# BNSF NORTHWEST DIVISION MEADOWDALE BEACH PARK RAILROAD BRIDGE

## SCENIC SUBDIVISION LINE SEGMENT 50 BRIDGE 21.8A AND BRIDGE 21.8B STRUCTURAL PLANS

**AS BUILT**

**DATE: JUNE 21, 2023**

TYPICAL SECTION - TEMPORARY SOIL RETENTION SYSTEM  
BY COUNTY CONTRACTOR

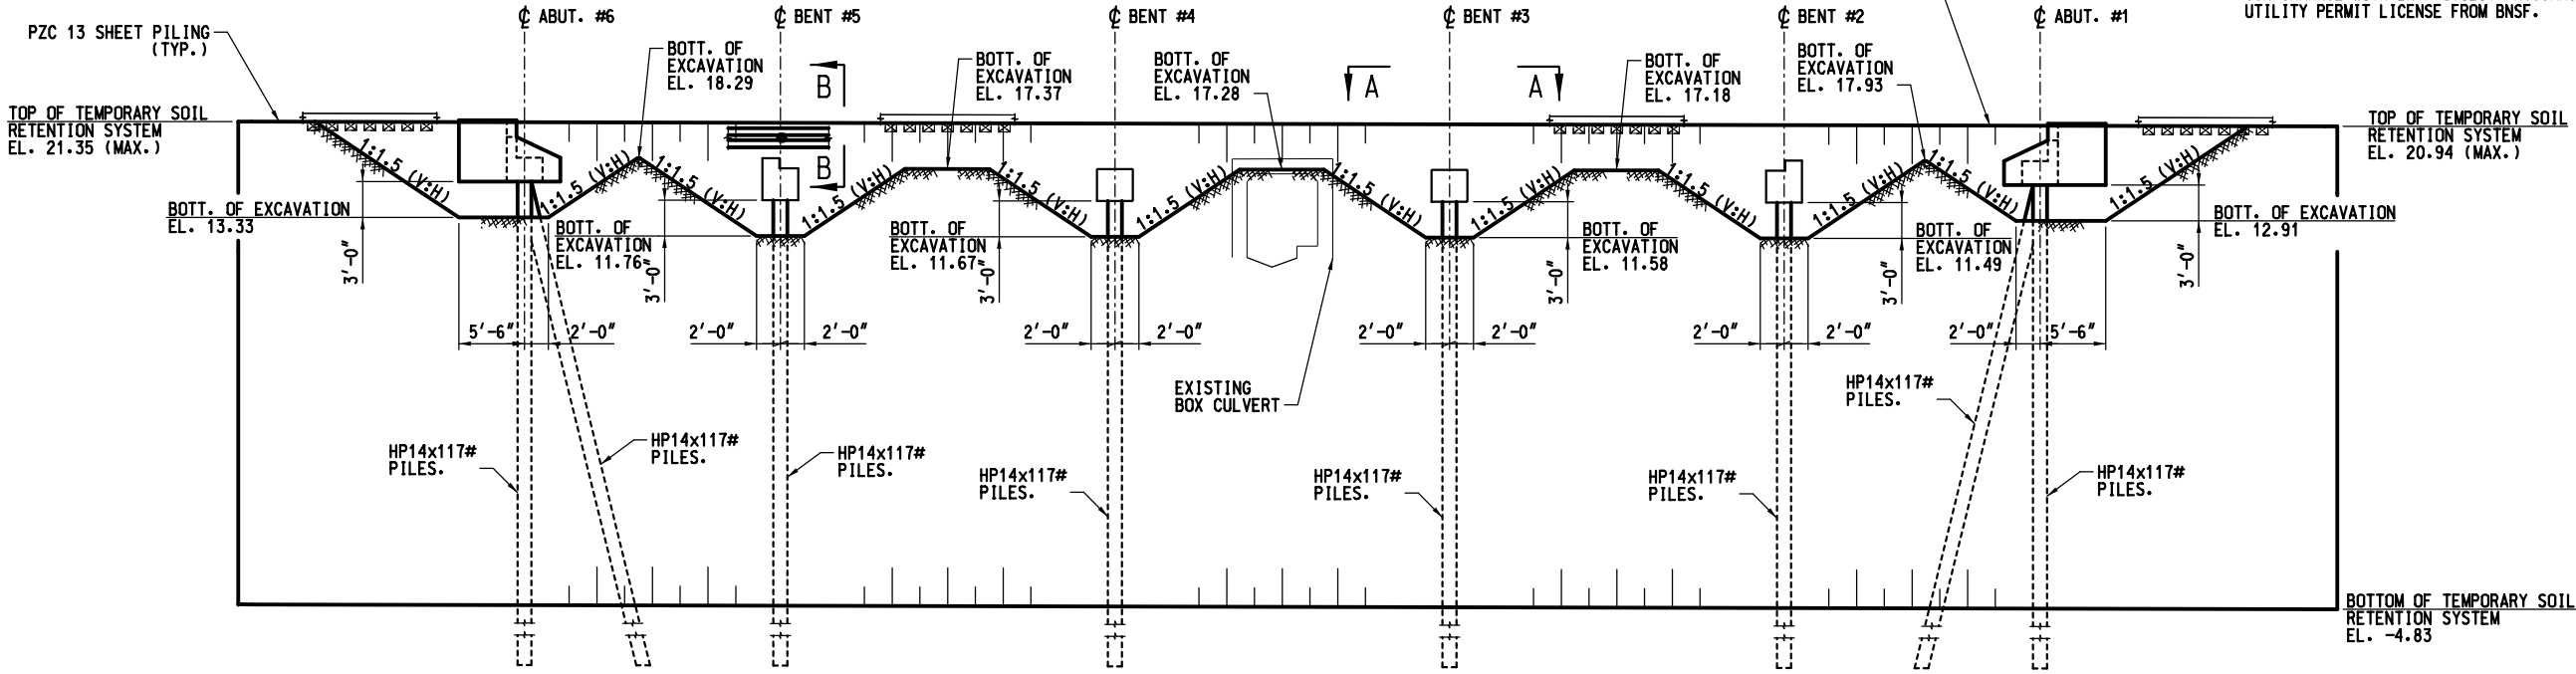
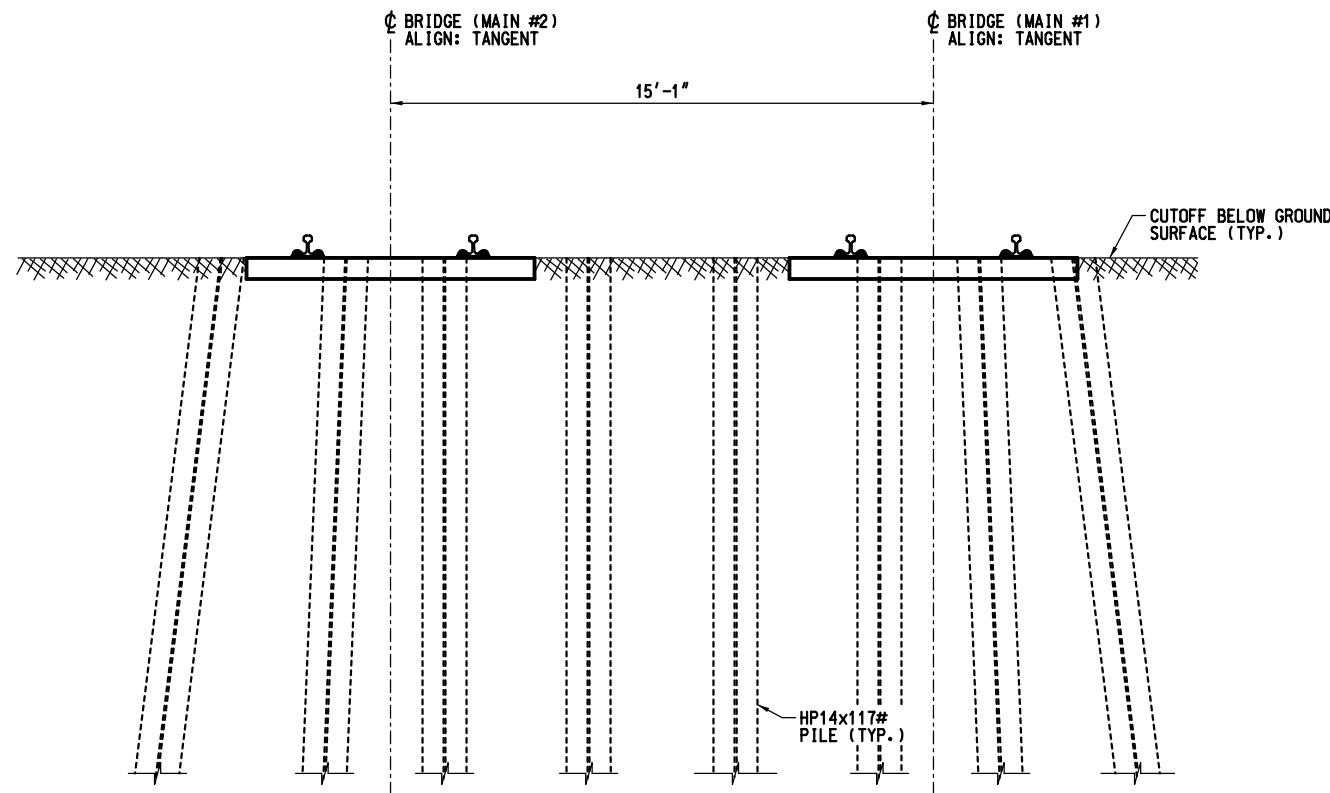
8. THE TEMPORARY SOIL RETENTION SYSTEM USED WAS A SINGLE WALL SHEET PILE, INSTALLED BETWEEN TRACKS DURING THE CONSTRUCTION OF THE BRIDGES.

SEATTLE, WA TO WENATCHEE, WA  
BRIDGE NUMBER 21.80B  
OVER LUND'S GULCH CREEK  
EDMONDS, WA  
CONSTRUCTION SEQUENCE  
STAGING SECTIONS I, II, & III  
PLAN NO: 0050-0021.800-014  
SHEET: 04 OF 10

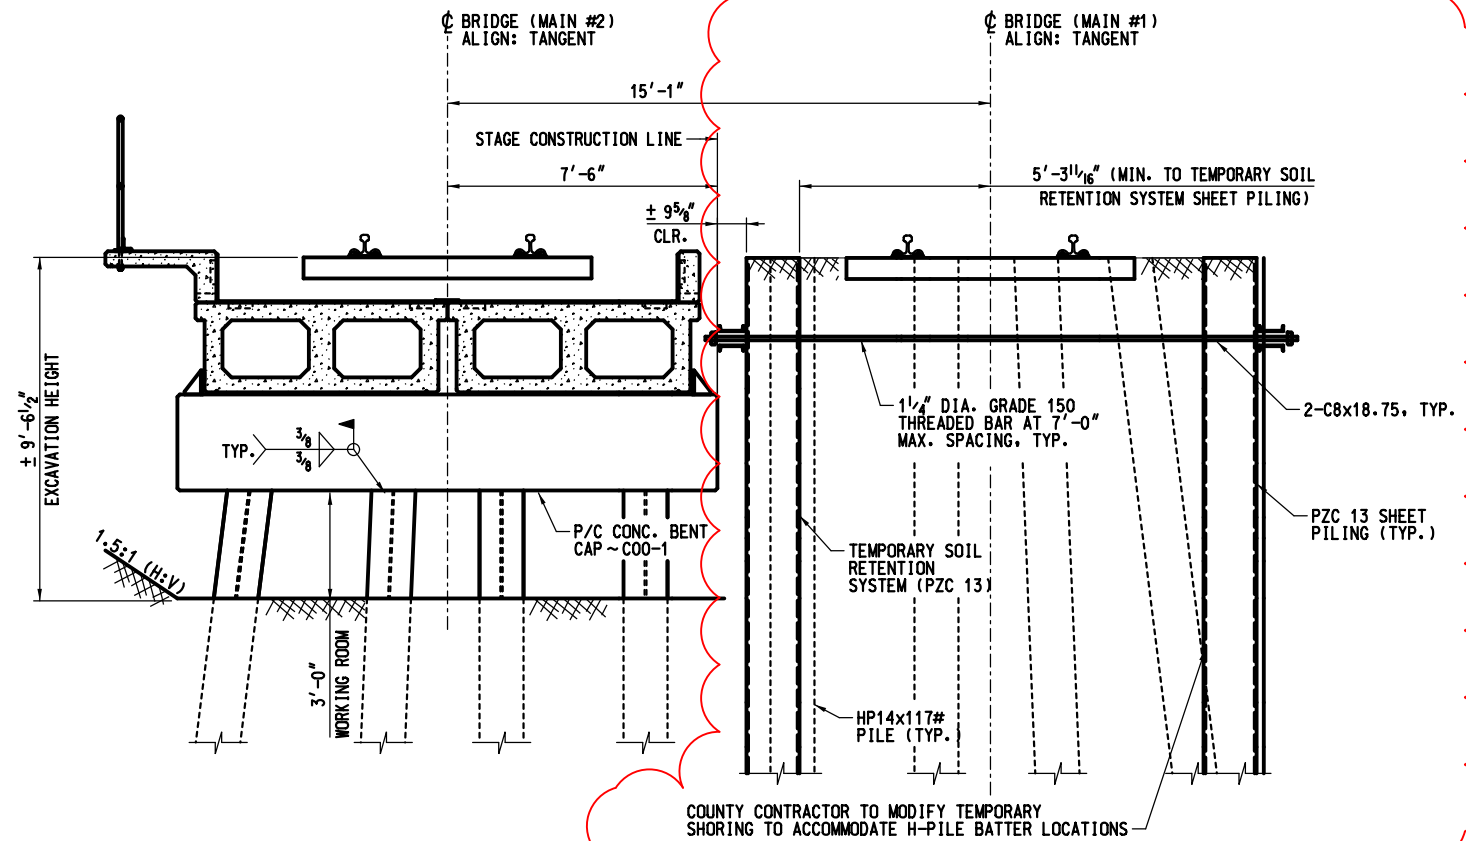
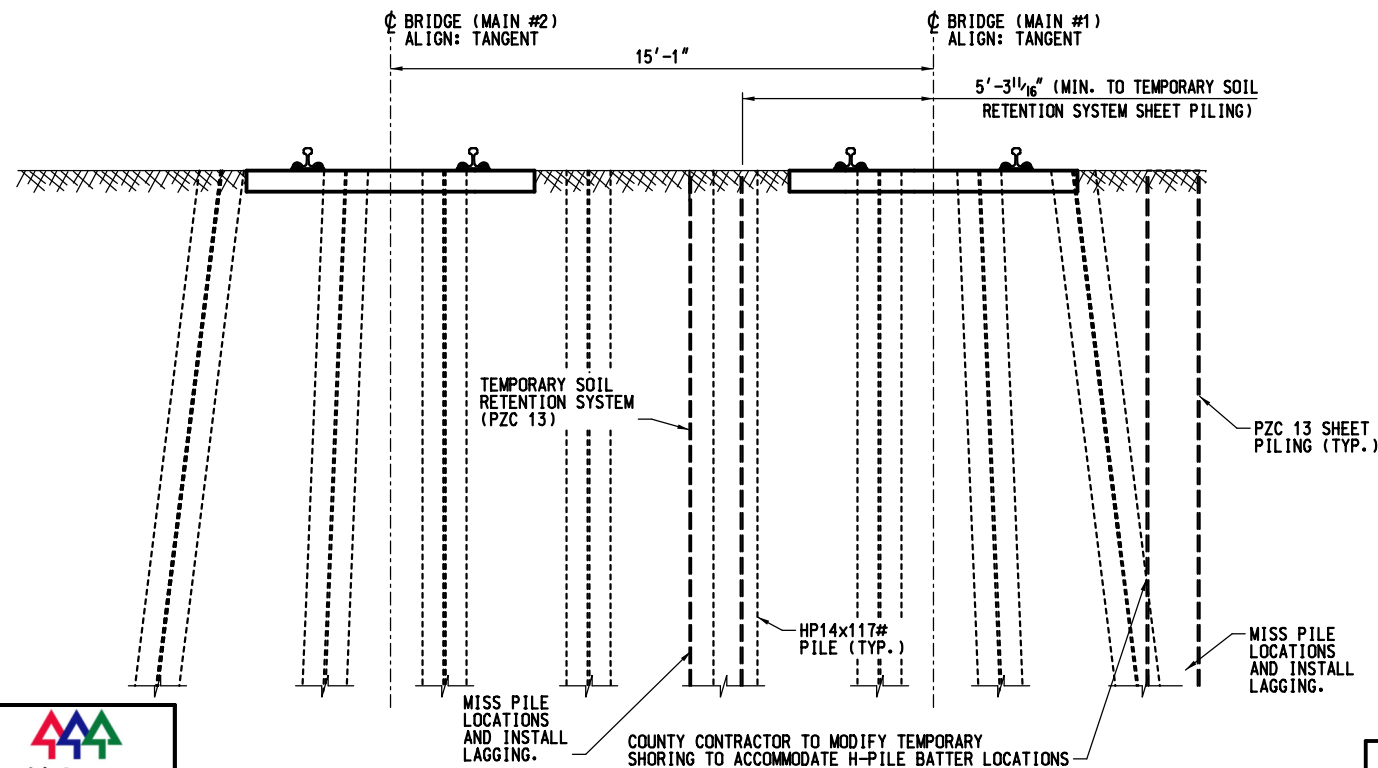
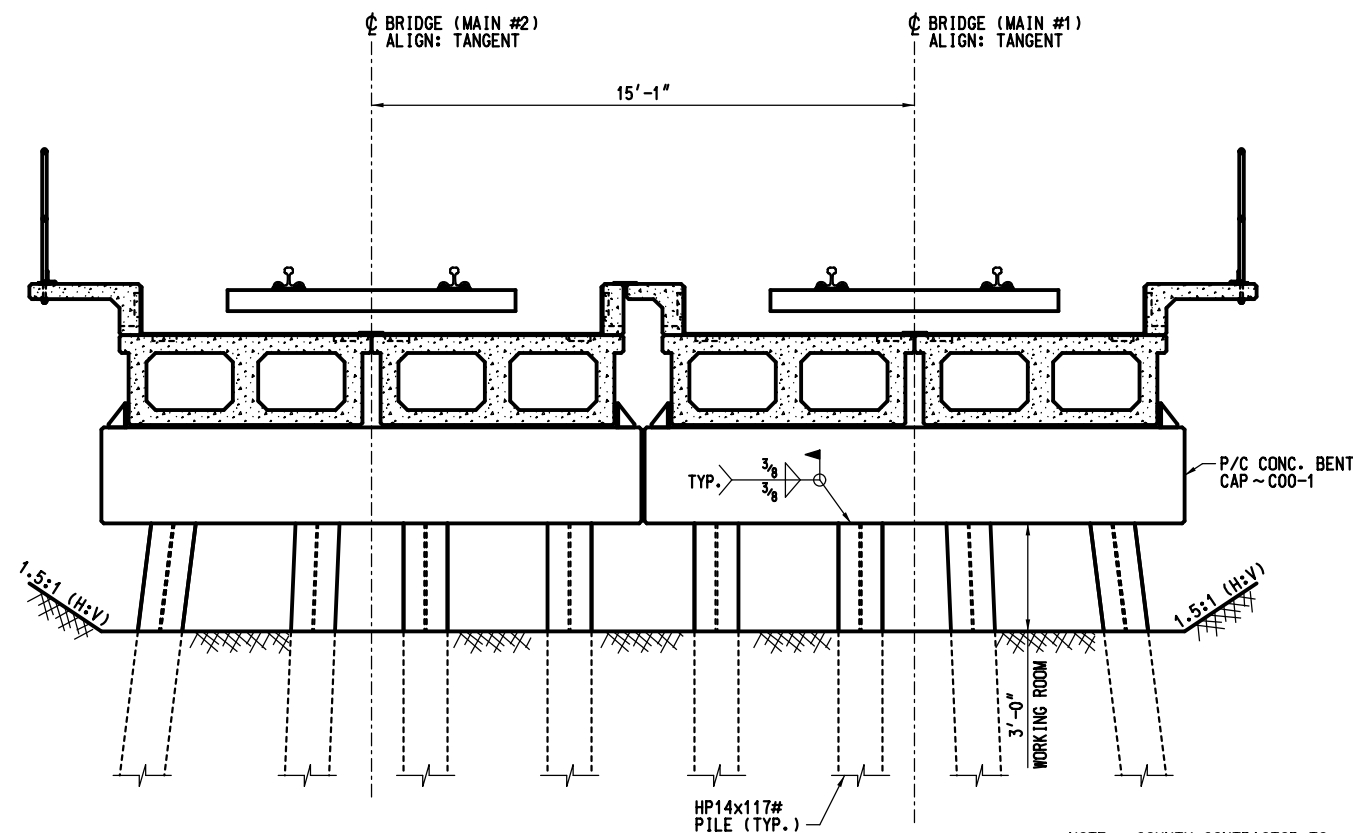
2 TEMPORARY SOIL RETENTION SYSTEM USED WAS SINGLE SHEET PILE WALL BETWEEN BOTH TRACKS. NO THREADED BARS USED. NO SHEET PILES WERE USED ON OUTER SIDES OF TRACKS.

**DECK DRAIN TYPICAL SECTION - BETWEEN BEAMS**

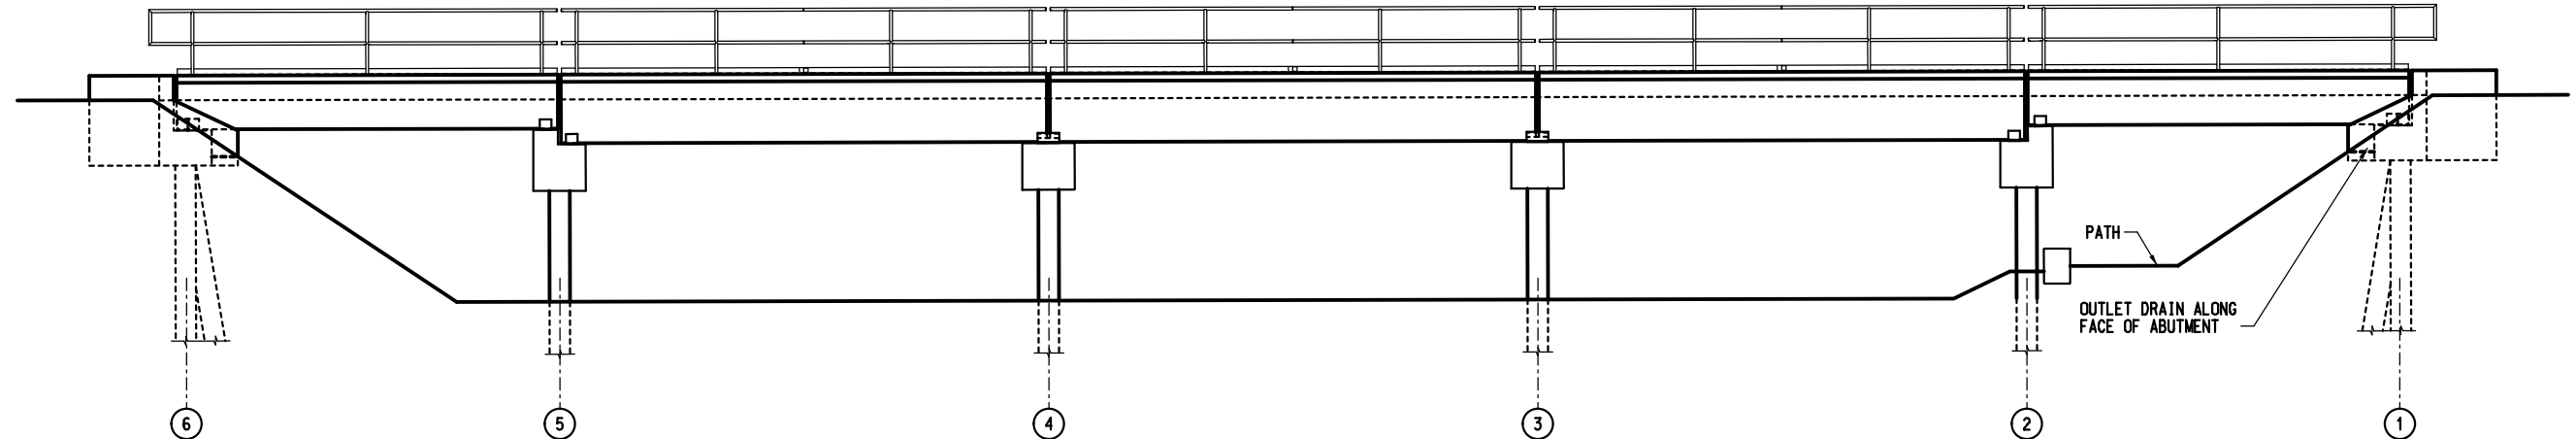
DRAINAGE SYSTEM REMOVED FROM SCOPE OF WORK.  
WATERPROOFING SYSTEM NOT INSTALLED.
